**STAFF RECOMMENDATION**  
**909 Manila Avenue**  
**May 15, 2019**

**Application:** New Construction—Addition; Setback Determination  
**District:** Greenwood Neighborhood Conservation Zoning Overlay  
**Council District:** 06  
**Base Zoning:** RS-5  
**Map and Parcel Number:** 08204041900  
**Applicant:** Meagan Webb  
**Project Lead:** Sean Alexander, sean.alexander@nashville.gov

**Description of Project:** An application to construct a one-story addition to an historic house. The addition will connect at the rear and will be wider than the original structure to the left side. A setback determination is required for the addition to be located eleven feet (11') from the rear property line.

Figure 1: View of 909 Manila Avenue from rear showing the existing non-historic addition that will be removed, and the location of the new addition.

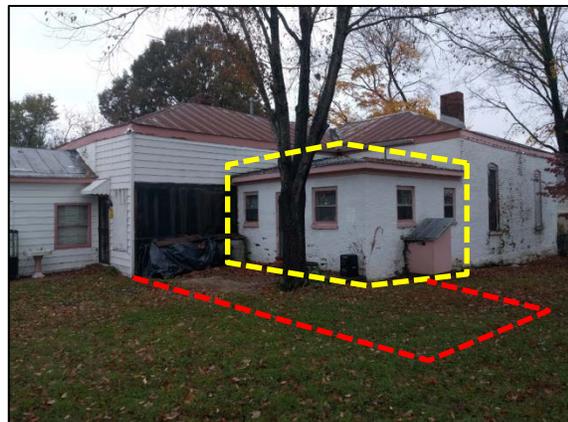
Demolition: The project will require a portion of an earlier rear addition to be demolished to accommodate the new addition. Because the portion of the building being removed is not historic, staff finds that the affected portion does not contribute to the architectural and historical character and significance of the district.

Staff finds that the proposed partial demolition meets Section III.B.2 for appropriate demolition and does not meet section III.B.1 for inappropriate demolition.

Figure 2: Site Plan from 2014 Subdivision

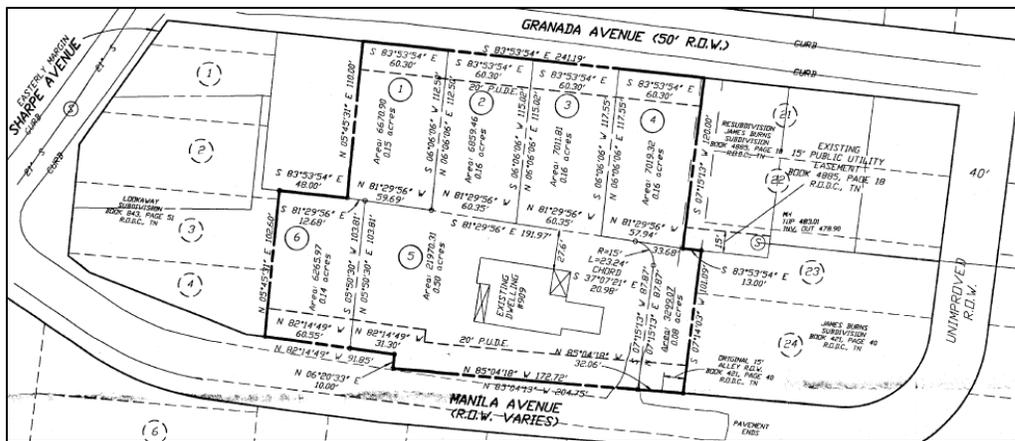
**Setback & Rhythm of Spacing:** The addition will extend seventeen feet (17') wider than the historic house to the north, and while this historically was the left side of the house it would be considered the rear of the lot because of the modern orientation. At this point, the house is already only twenty-seven feet (27') from the rear property line, which is not a typical condition in the district. The applicant is therefore requesting a setback determination for an eleven foot (11') rear setback, as the addition would step nine feet (9') into the standard twenty foot (20') setback buffer.

Staff finds that the addition would not disrupt the rhythm of spacing within the historic house and surrounding context, and that the project therefore meets section II.B.1.c. of the design guidelines.
